**Technical Submission Review: Prairie Point Site Plan No 3 (Kings Point North) – Site Plan and Plat**  
**Application Number: DA-1609-26**  
**Case Numbers: 2023-4009-00; 2023-3026-00**

On behalf of Clayton Properties Group LLC, Redland, Fox Tuttle Transportation Group, and Terracina Design, we have reviewed the comments from the 3rd Submission Review for Site Plan 3 (Kings Point North). The following is a response to comments:

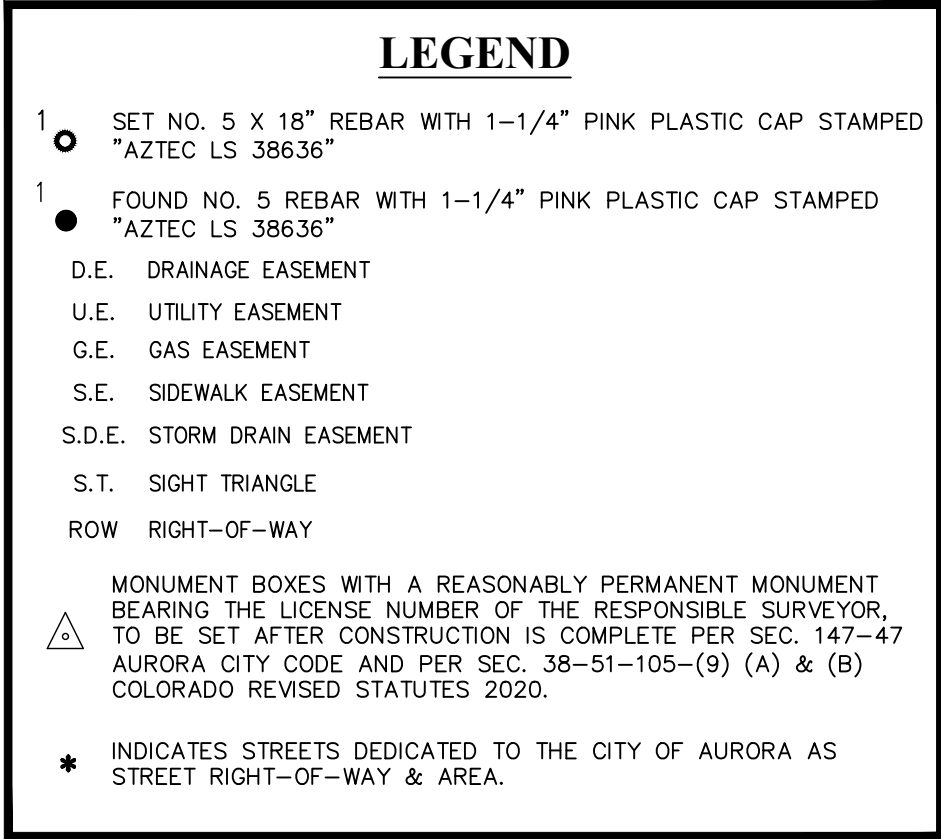
what are these lines?

DETAIL A  
SCALE: 1" = 50'

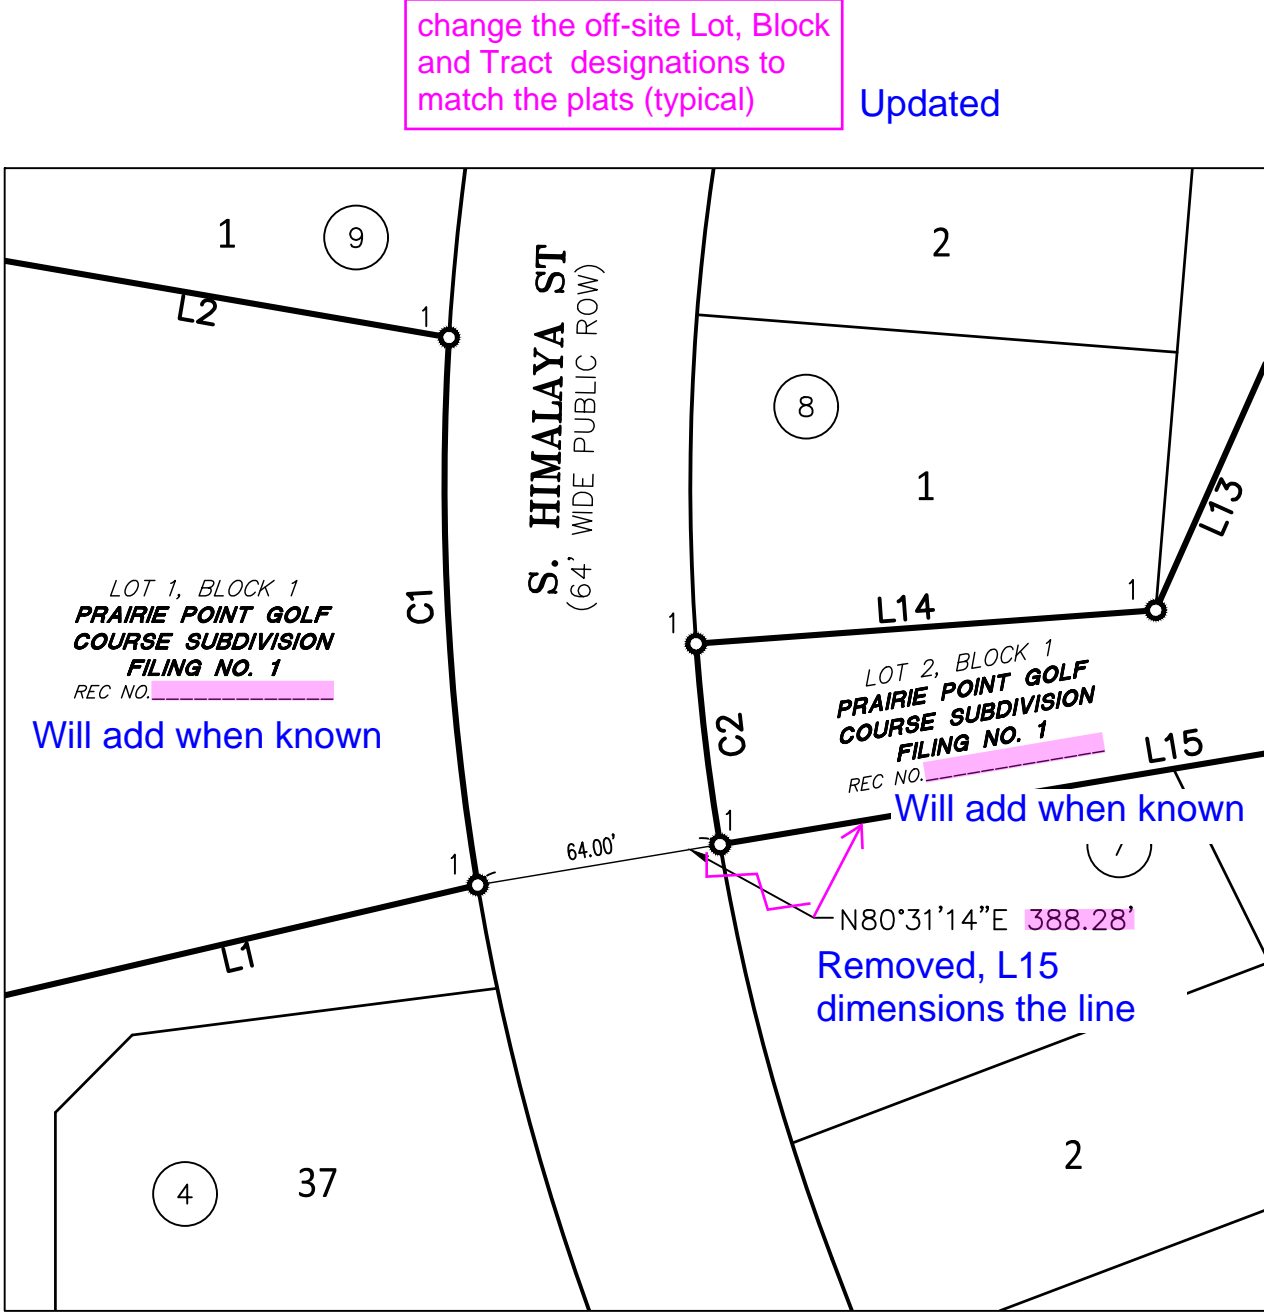
change the off-site Lot, Block and Tract designations to match the plats (typical)

Updated

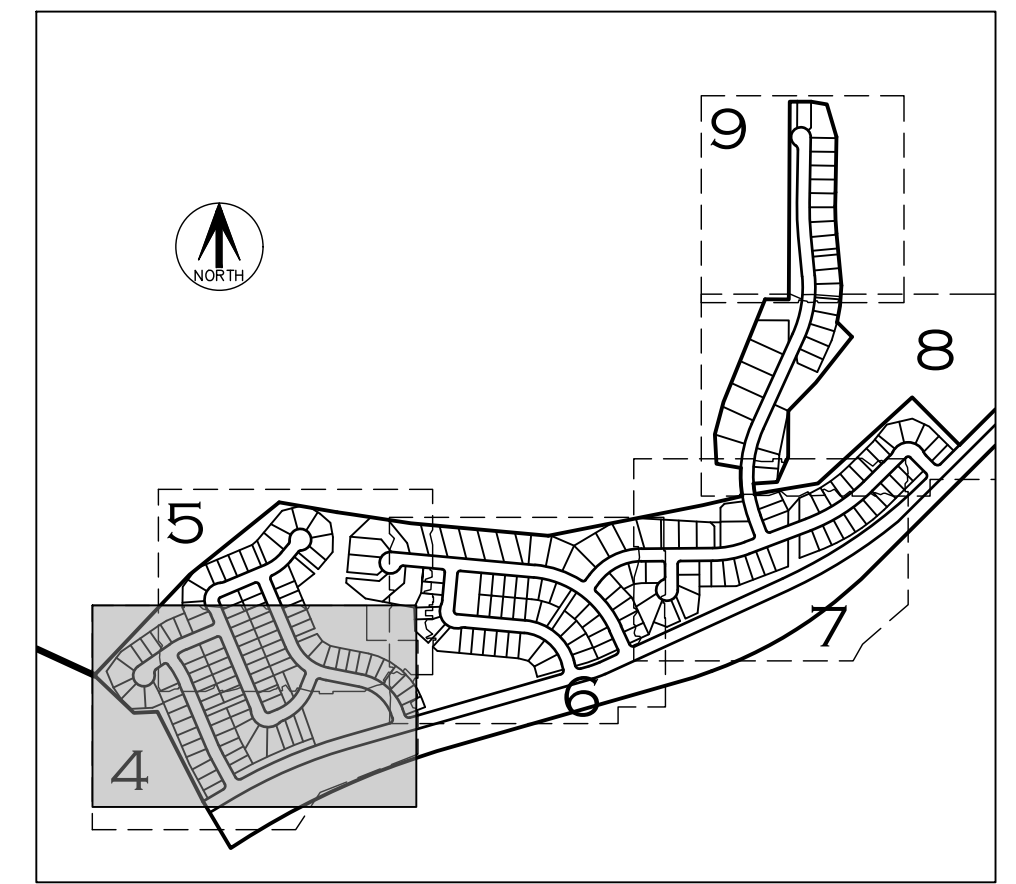
change to the water  
type easement here -  
confirm with Aurora  
Water Dept.  
Revised

delete this easement -  
the private easement  
cannot be dedicated  
by the plat (remove  
the line work)  
Revised  
call out

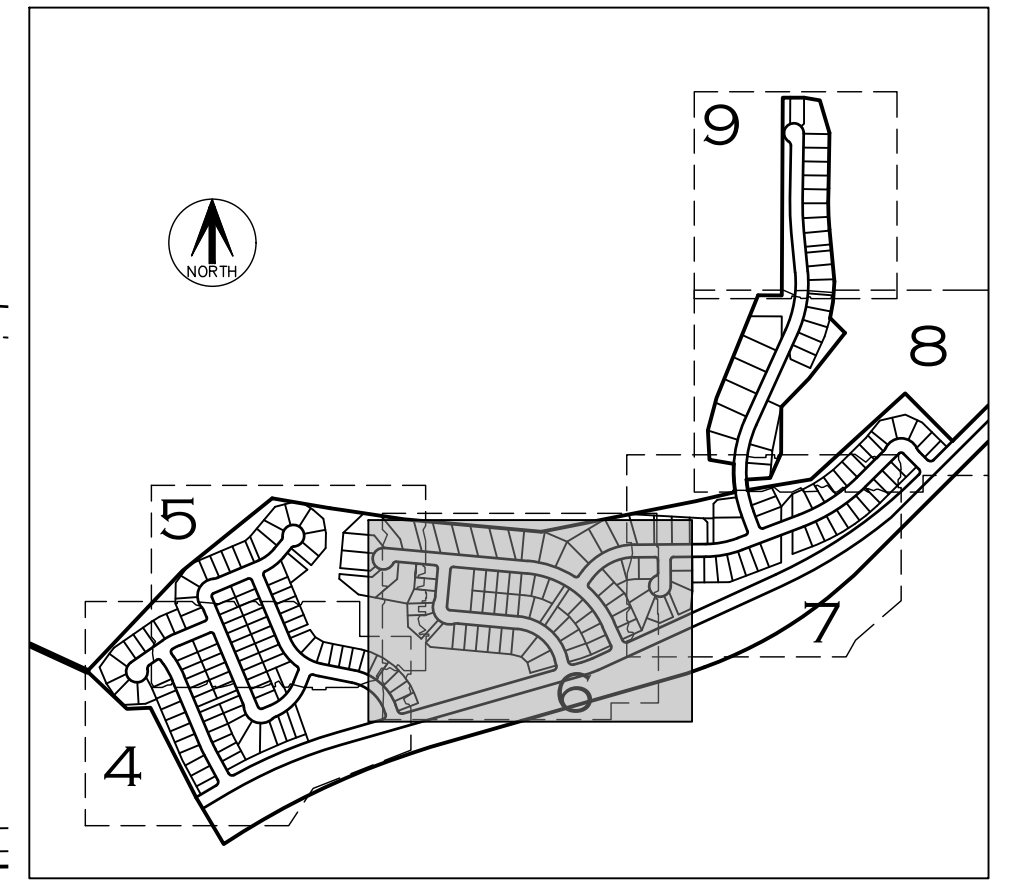
fill in the blanks (typ.)  
Will add when known

change the off-site Lot, Block  
and Tract designations to  
match the plats (typical)  
Updated

text overlap Revised

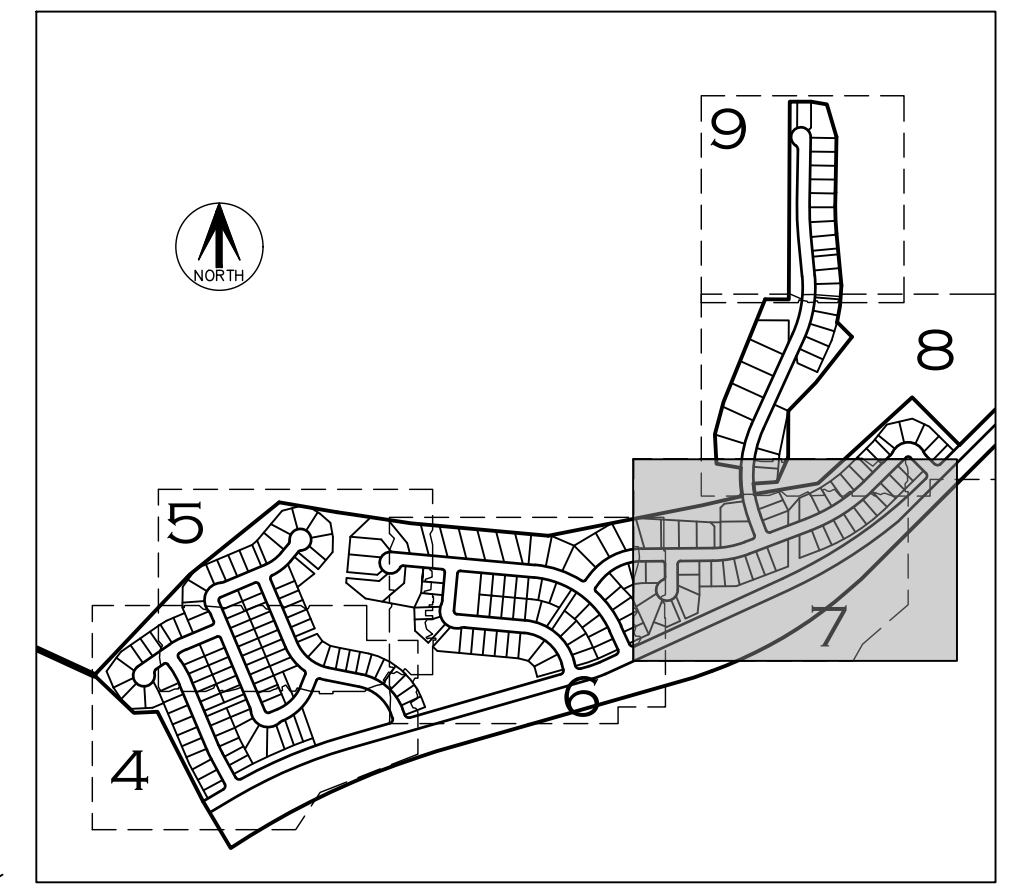
fill in the blanks (typ.)

change the off-site Lot, Block and Tract designations to match the plats (typical)

Will add when known

Updated

SHEET 8 OF 9

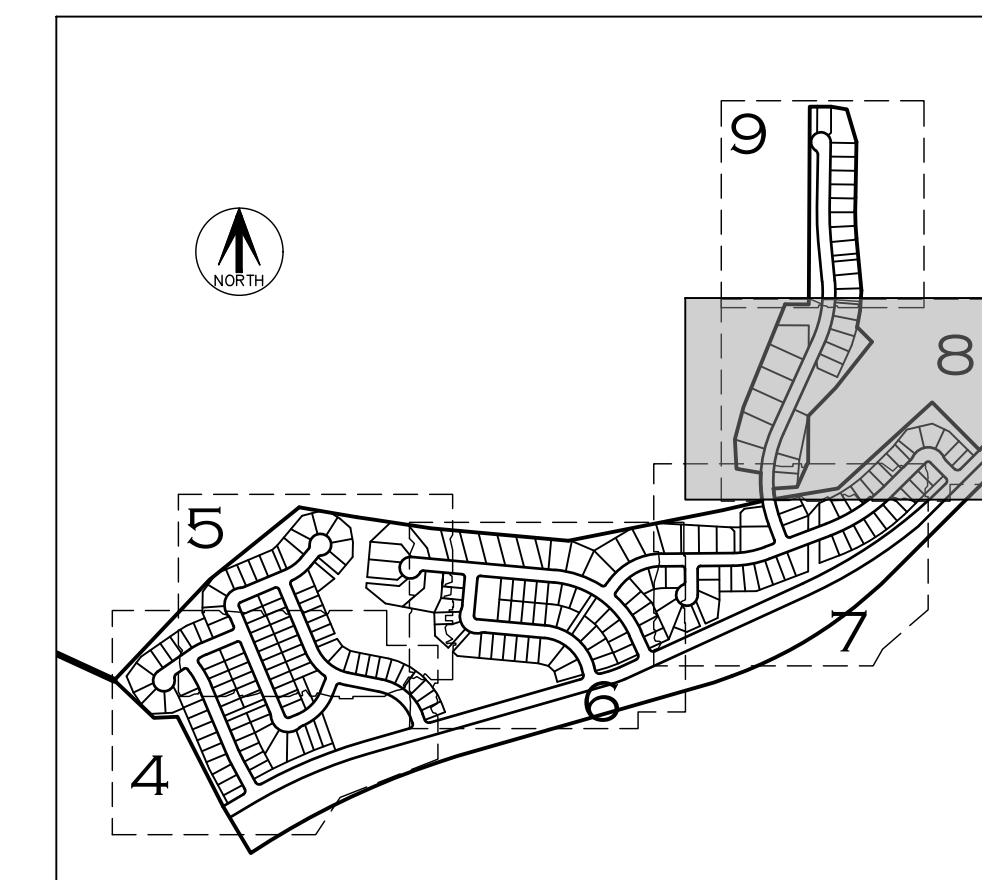
change the off-site Lot, Block  
and Tract designations to  
match the plats (typical)

Fill in this info or add:  
"to be dedicated by  
separate document"  
Revised call out

dedicate this portion of  
the Drainage easement  
by separate document  
Revised call out
